**Project #24-012
Salad Spot
623 North Main Street**

Project Name: Salad Spot
Proponent/Owner: Dan Rigby / Bill Bagley, Peterson Group Commercial LLC
Project Address: 623 North Main Street
Request: Design Review Permit
Current Zoning: Commercial (COM)
Date of Hearing: March 14, 2024
Type of Action: Quasi-Judicial
Submitted By: Tanya Rice, Planner

Staff recommends that the Planning Commission (PC) conditionally **approve** a Design Review Permit for Project #24-012 Salad Spot for a new 800 SF commercial building located at approximately 623 North Main Street: TIN #05-048-0029.

Title:
 Elevations

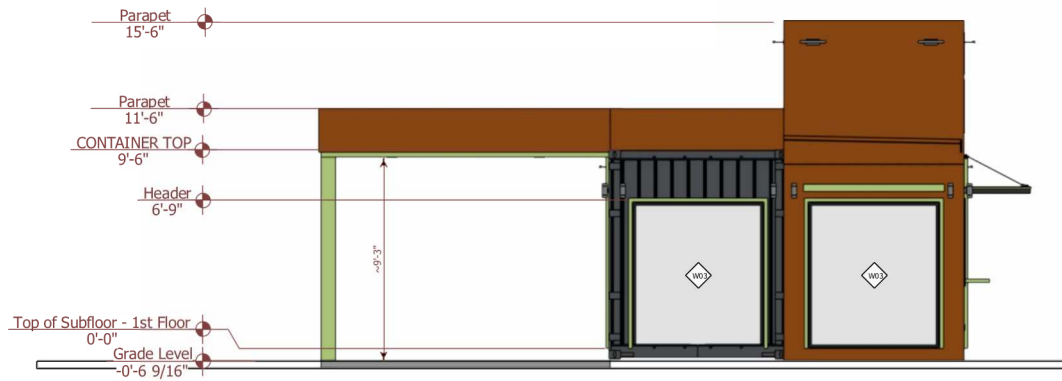
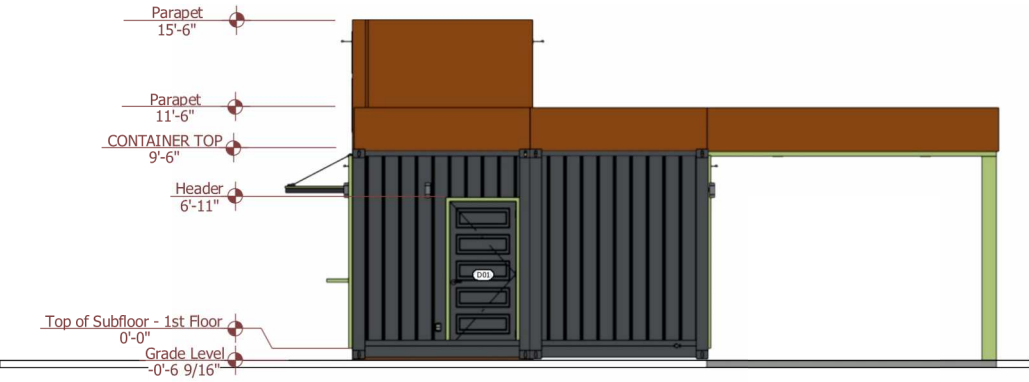
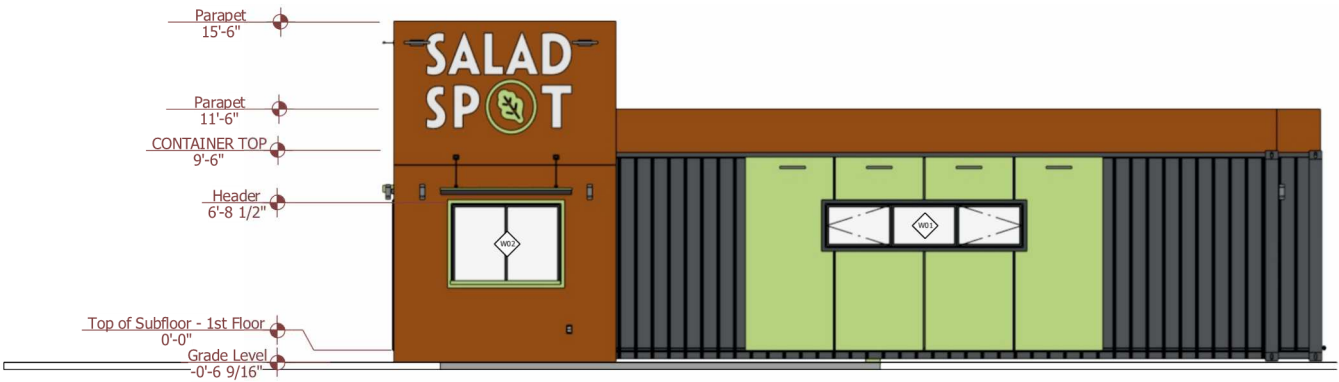
The proposed site plan shows the drive-thru canopy projecting to the southern property line, but the elevations and confirmation from the applicant indicate the drive-thru canopy is 4' from the property line (Figure 3). As conditioned, with a 5' minimum between the property line and the drive-thru canopy, the project meets minimum setback requirements of the LDC.

Figure 3 Elevation showing drive-thru canopy 4' from the property line.
